Technical Service Bulletin

SUBJECT:		No: TSB-20-11-001	
CHANGES TO DRIVE BELT AND TENSIONER PROCEDURES - SMR - REVISED		DATE: February 2020	
		MODEL: See below	
CIRCULATE TO:	<input type="checkbox"/> GENERAL MANAGER	<input checked="" type="checkbox"/> PARTS MANAGER	<input checked="" type="checkbox"/> TECHNICIAN
<input checked="" type="checkbox"/> SERVICE ADVISOR	<input checked="" type="checkbox"/> SERVICE MANAGER	<input type="checkbox"/> WARRANTY PROCESSOR	<input type="checkbox"/> SALES MANAGER

This bulletin supersedes TSB-13-11-009, issued September, 2013, to add additional affected model years and additional corrections to Service Specifications. Revisions are indicated by ◀.

This TSB updates the Engine section of the affected Service Manuals, to revise the accessory drive belt and tensioner repair and maintenance procedures.

DRIVE BELT AUTO-TENSIONER CHECK

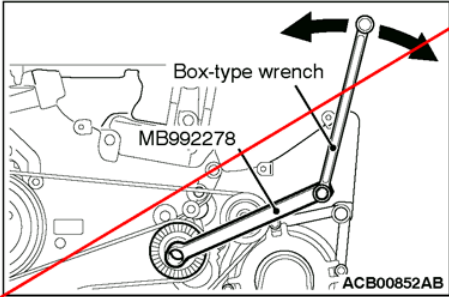
<Deleted>

~~MB992278: Belt tension release wrench~~

Replace with information on next page

FUNCTION CHECK

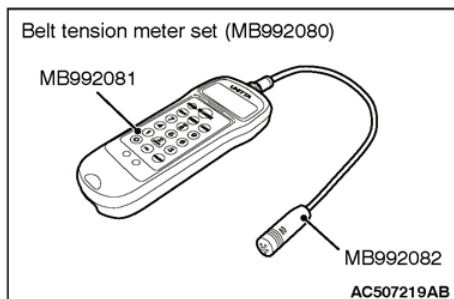
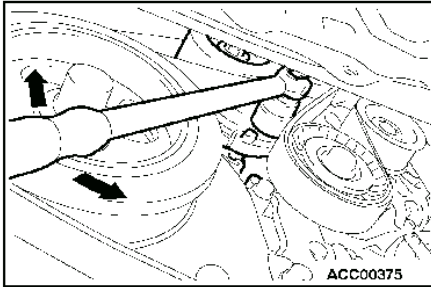
<New>

⚠ WARNING

Be sure to set the tool to the hexagonal part securely to prevent the tool from falling off because the tension of the auto-tensioner is high.

5. Securely set the tool to the hexagonal part of the auto-tensioner.

**ENGINE MECHANICAL
CRANKSHAFT PULLEY**

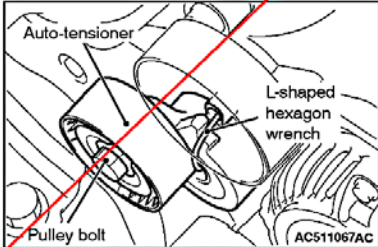
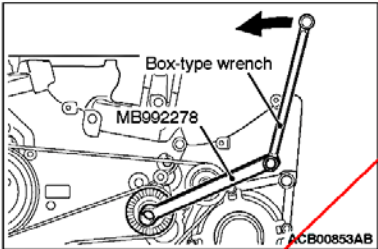
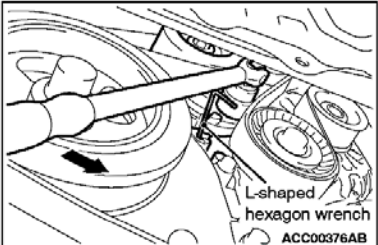
<Old>

WARNING
Always work from above when releasing the tension of the auto-tensioner. When you try to gain access from underneath the vehicle, you will experience difficulty, thus causing the tool to be dropped off.

CAUTION
To work at the optimum angle, you must choose a most suitable box-type wrench is applied to the special tool.

WARNING
Be sure to set the box-type wrench and the special tool to the hexagonal parts securely to prevent the tool from falling off because the tension of the auto-tensioner is high.

1. Install special tool MB992278 and a box-type wrench at the optimum angle.
2. Rotate the pulley bolt of the auto-tensioner counterclockwise.
3. Insert the L-shaped hexagon wrench into the auto-tensioner hole to fix the auto-tensioner.
4. Remove the drive belt.

WARNING
Be sure to set the tool to the hexagonal part securely to prevent the tool from falling off because the tension of the auto-tensioner is high.

1. Securely set the tool to the hexagonal part of the auto-tensioner.
2. Rotate the auto-tensioner counterclockwise.
3. Insert the L-shaped hexagon wrench into the auto-tensioner hole to fix the auto-tensioner.

ENGINE MECHANICAL <2.4L ENGINE> ON-VEHICLE SERVICE

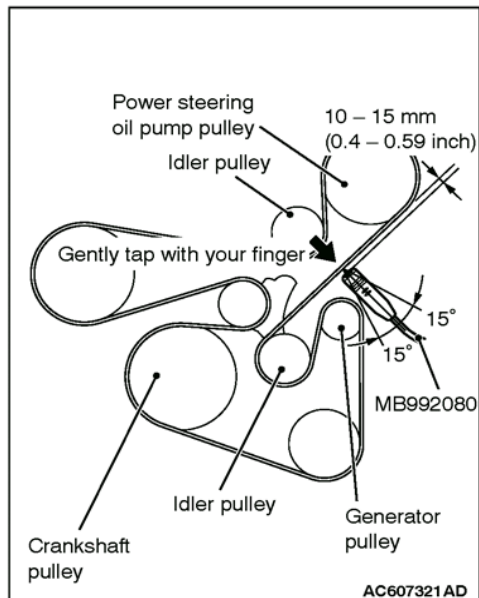
Standard value (Reference): ~~105 - 135 Hz~~ **102 - 131 Hz** <Old> <New>

**ENGINE MECHANICAL <2.4L ENGINE>
ON-VEHICLE SERVICE**

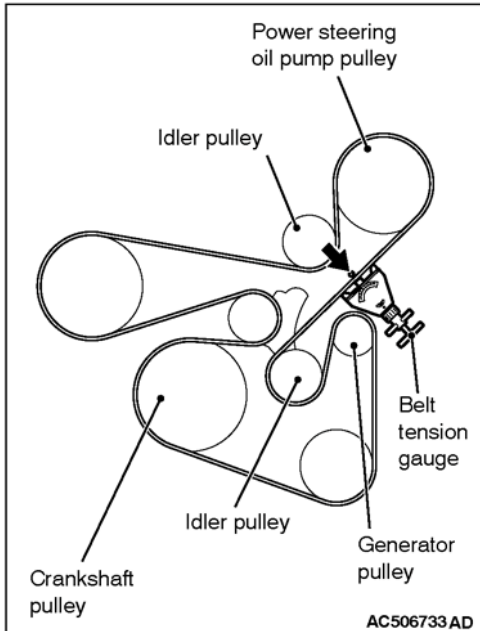
Standard value (Reference): ~~262 – 430 N (59 – 97 lb)~~ ←

260 – 421 N (59 – 94 lb)
<New>

ENGINE OVERHAUL <2.4L ENGINE>
 GENERATOR AND IGNITION SYSTEM

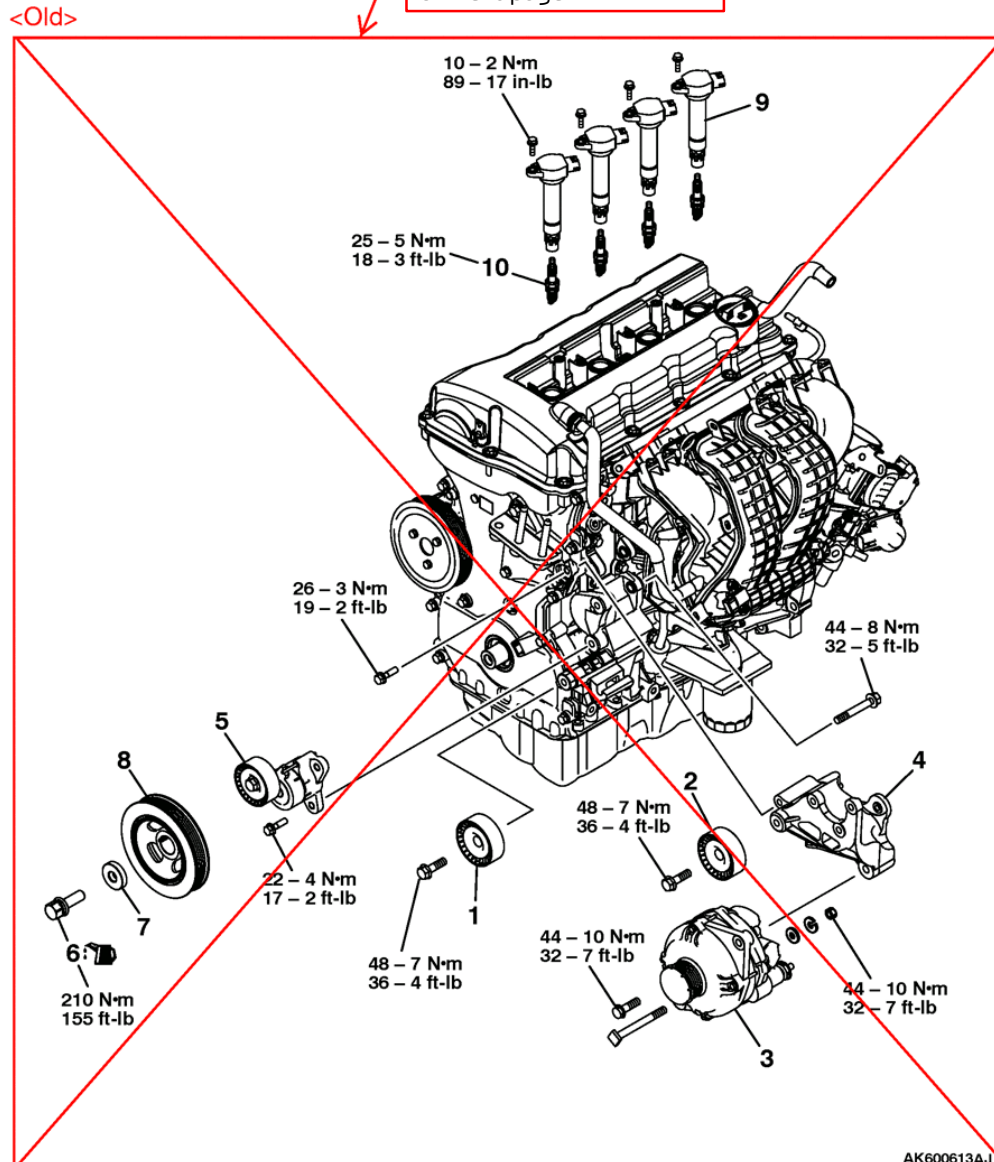
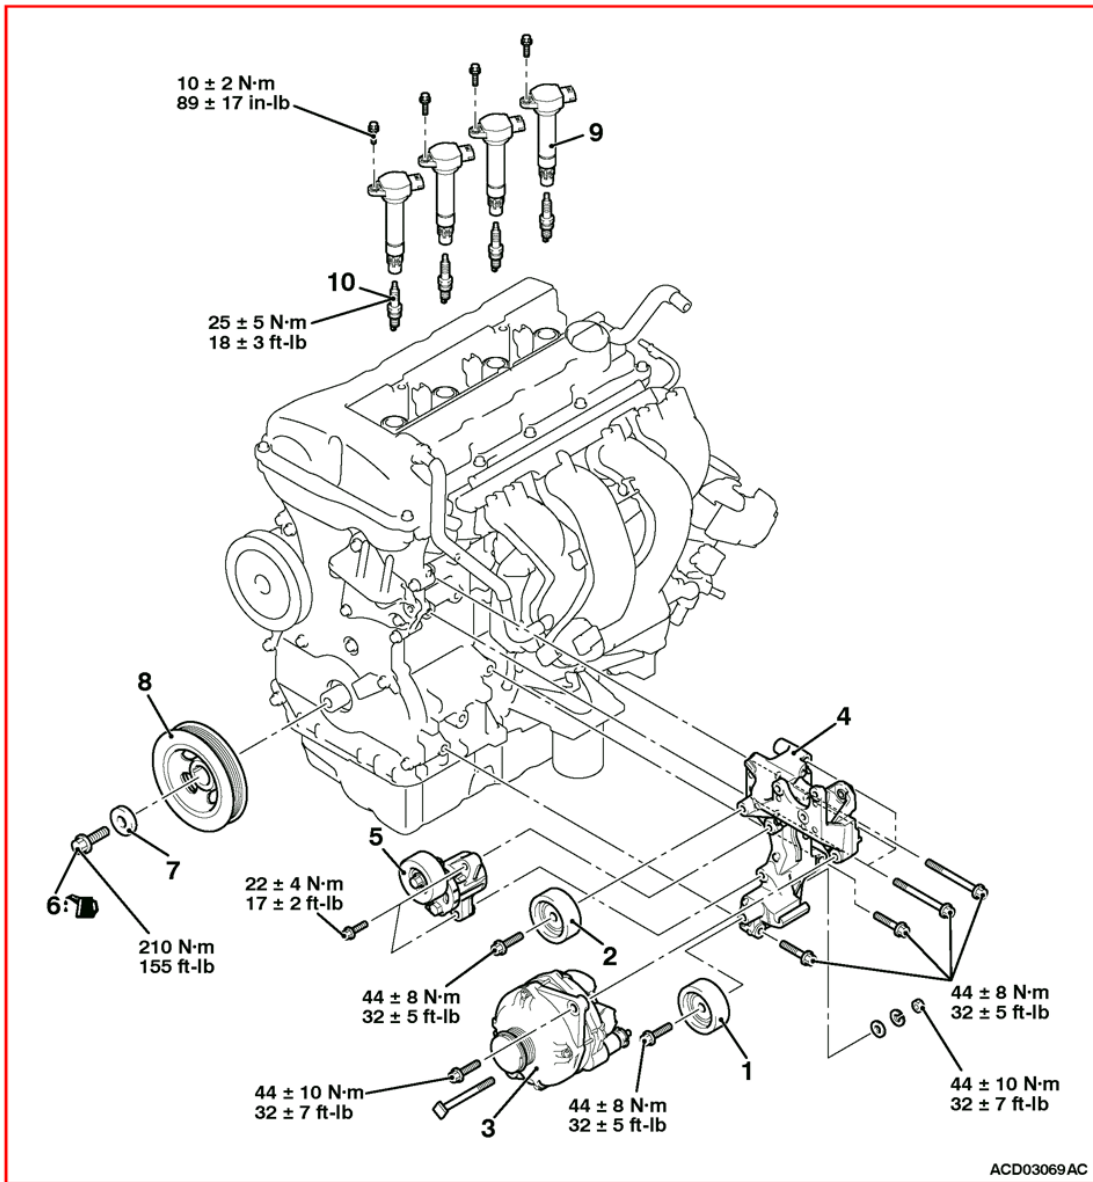
Please make the indicated changes relating to the following information in the 2013 & 2014 Lancer/Lancer Sportback Service Manuals, Group 11-Engine -> 11F-Engine Overhaul -> Generator and Ignition System -> Removal and Installation

Replace with information on next page

<New>

SERVICE SPECIFICATIONS

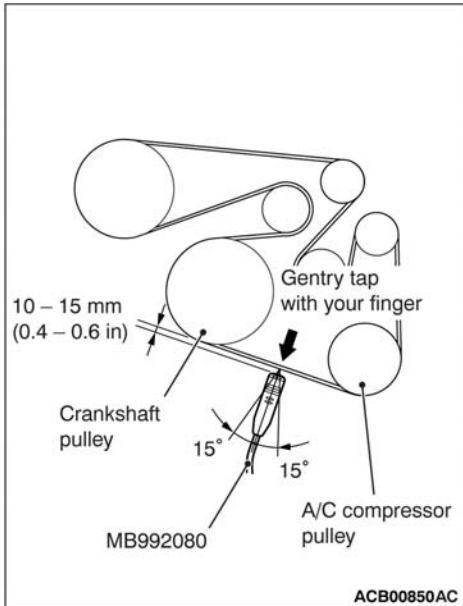
Item		Standard value	Limit
Drive belt tension	Vibration frequency Hz (Reference)	115 - 156 <Old>	-
	Tension N (lb) (Reference) <Old>	234 - 421 (52.7 - 94.6)	-
Valve clearance (at cold) mm (in)	Intake valve	0.20 ± 0.03 (0.008 ± 0.0012)	-
	Exhaust valve	0.30 ± 0.03 (0.012 ± 0.0012)	-

<New>
123 - 156

<New>
268 - 421
(60.3 - 94.6)

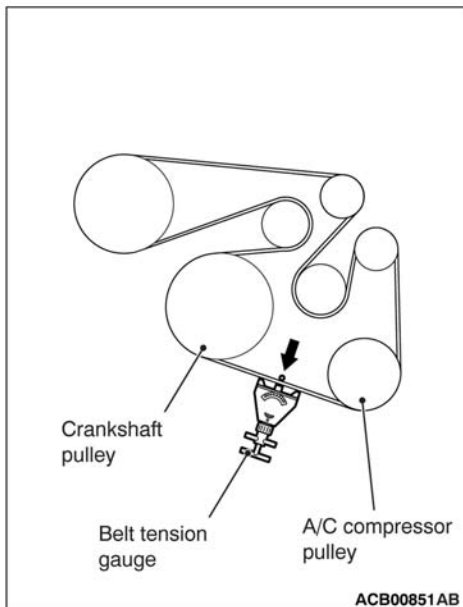
- <Old>
- Standard value (Reference):** ~~234 - 421 N (52.7 - 94.6 pounds)~~
3. If not within the standard value, replace the drive belt auto-tensioner (Refer to _____).

<New>
268 - 421 N (60.3 - 94.6 lb)
